**42 HAMPSTEAD LANE
LONDON, N6 4LL**

NMA APPLICATION 2
NOVEMBER 2022

SUMMARY OF CHANGES

CONSENTED VS NMA 2 PROPOSALS

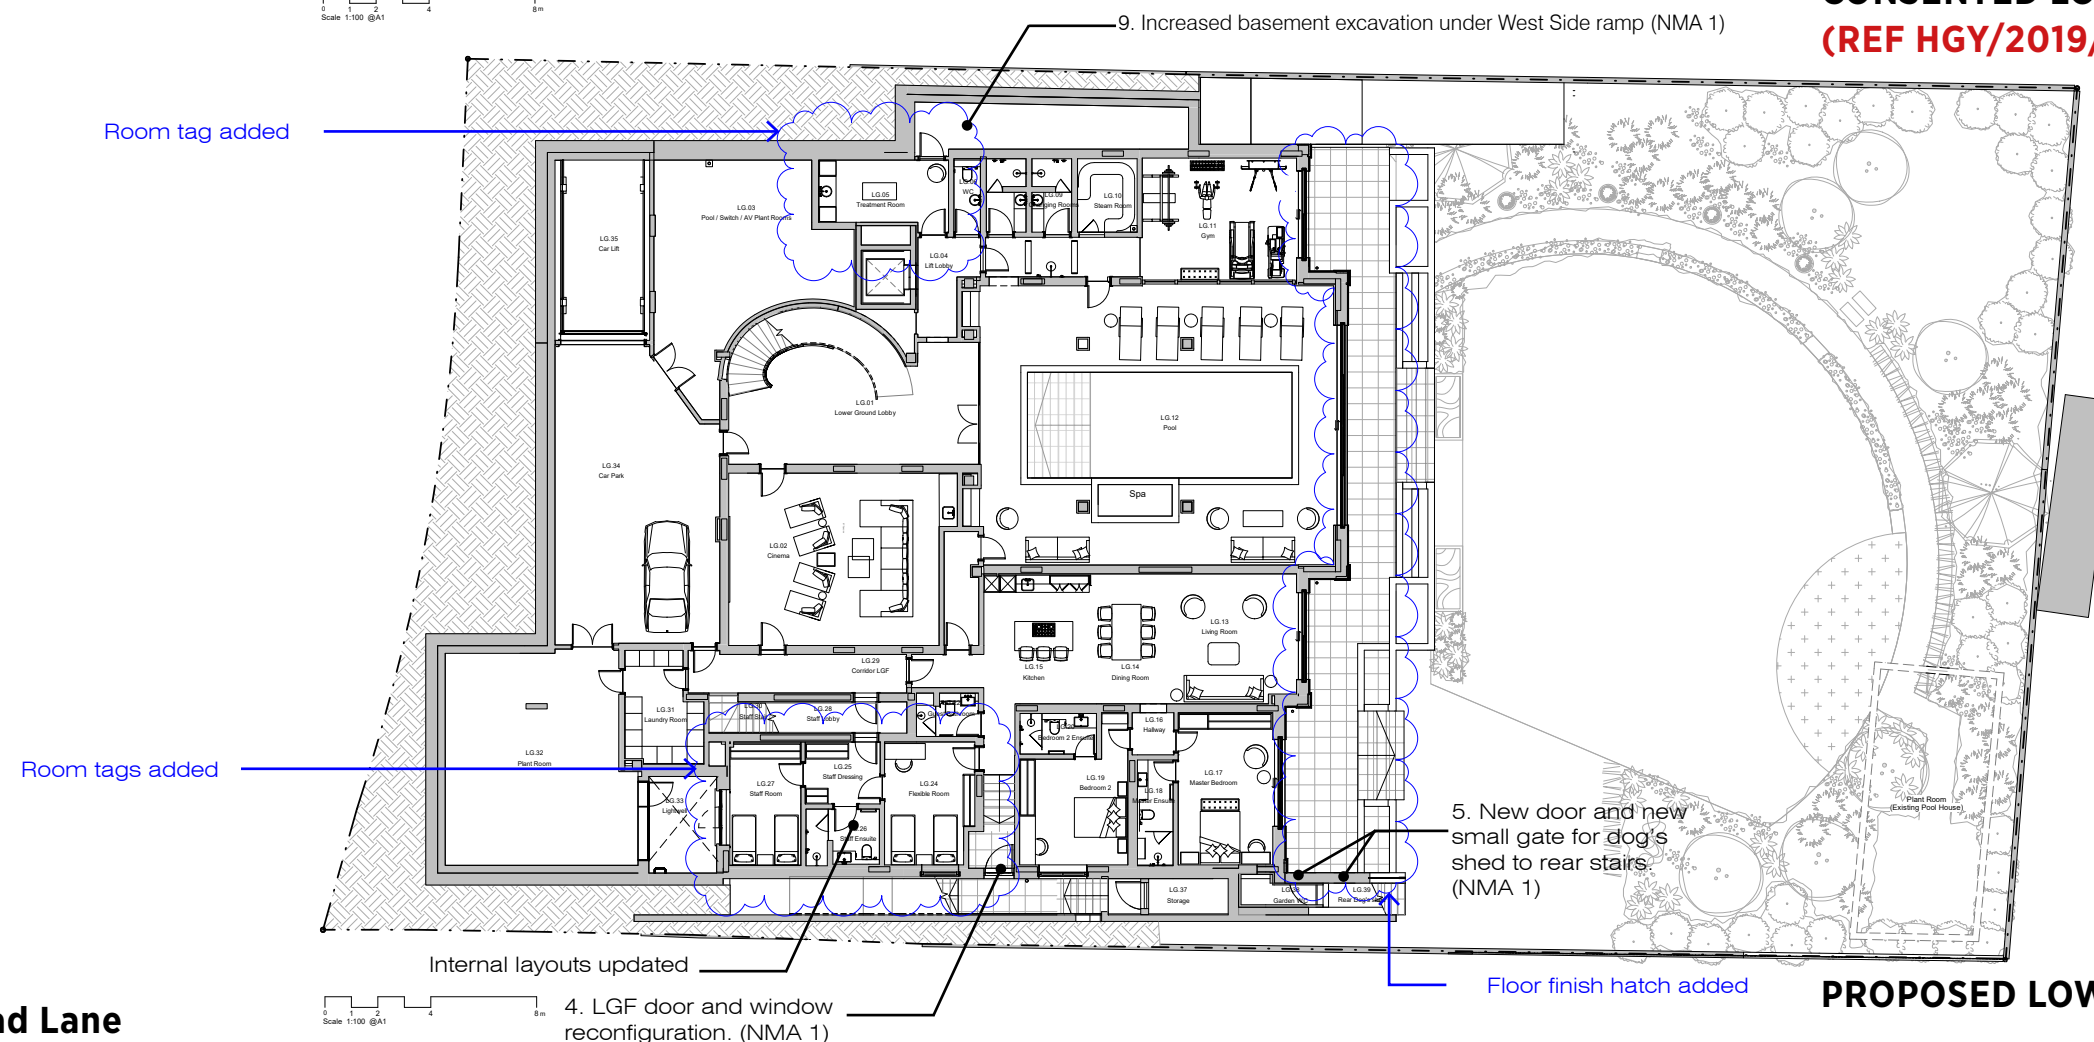
NMA 1	NMA 2
1. New solid door to front facade	NMA 1 +
2. Windows to west facade repositioned and shape updated	18. All sash windows to be casement.
3. Kitchen window omission to east facade	19. All glazing bars to windows omitted.

4. LGF door and window reconfiguration.	20. Rear Lower Ground Floor windows be sliding doors.
5. New door and new small gate for dog's shed to rear stairs

6. Lift overrun.	
7. Rear windows to GF Formal living to be arched.	
8. Glazed overhead panel to front door omitted	
9. Increased basement excavation under West Side ramp.

10. Ground floor and First Floor quoins to be stone & central rear bay quoins omitted	
11. Roof lights to be repositions / omitted.	
12. Stone fascia added to front and rear dormers

13. External rear staircase reconfiguration	
14. Reconfiguration of rear facade windows.	
15. Orangery composition updated.	
16. Roof hatch added for maintenance.

17. Chimneys update.

PROPOSED FRONT DORMER

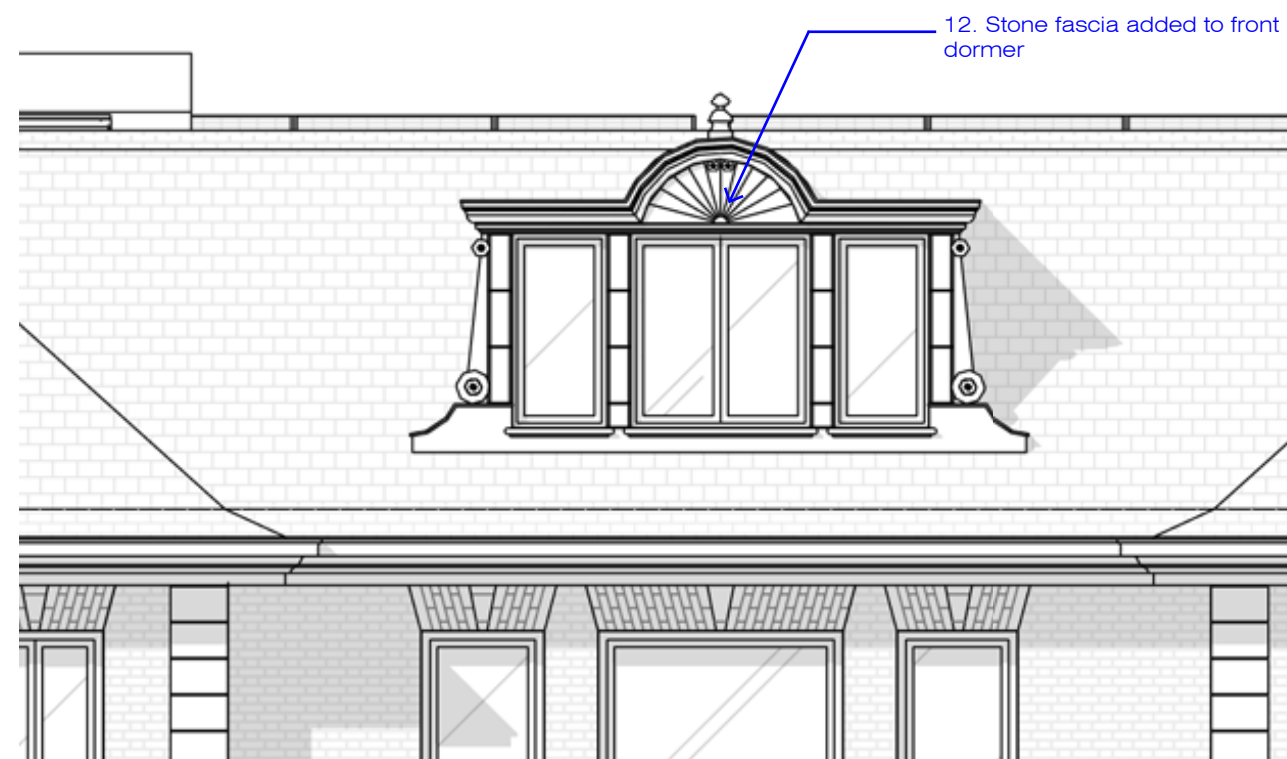
Page added to clarify proposed
front dormer

PROPOSED REAR DORMER

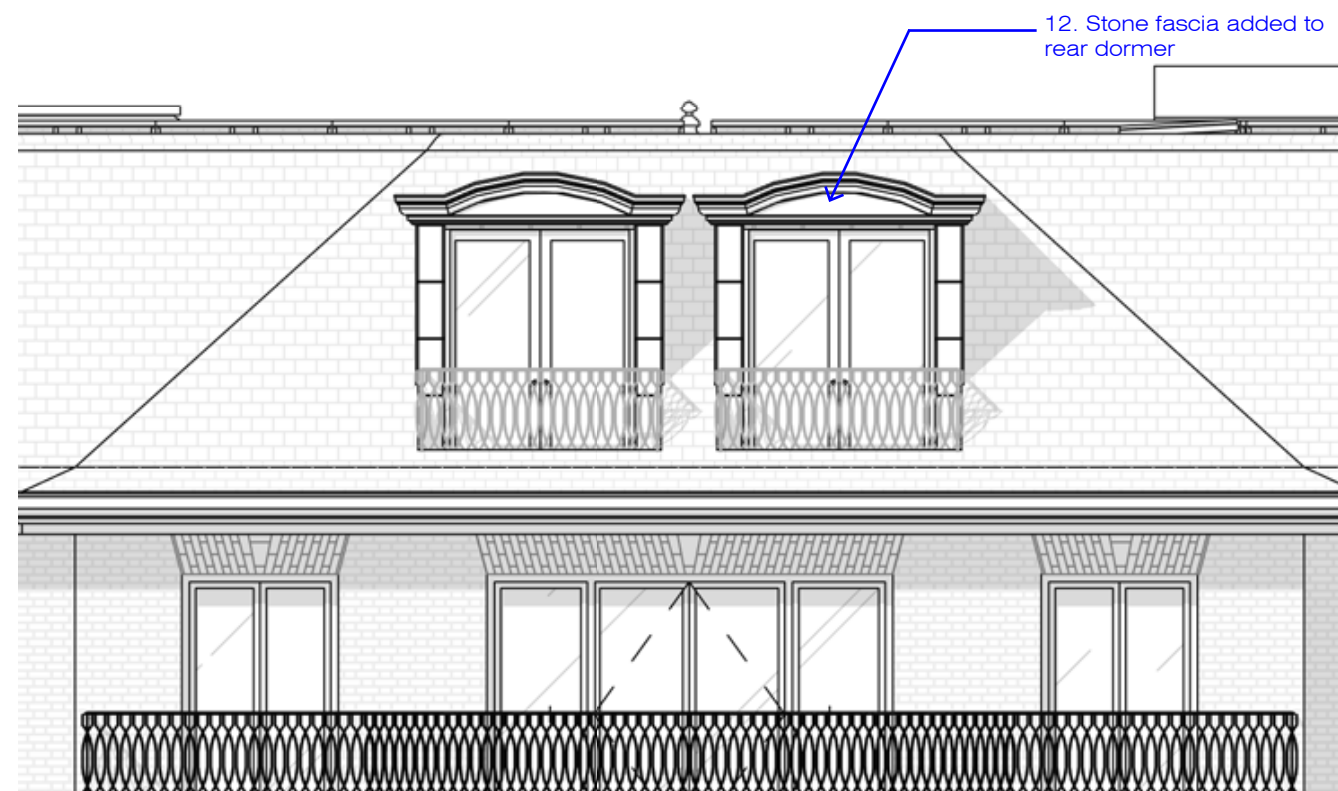
Page added to clarify proposed
rear dormer
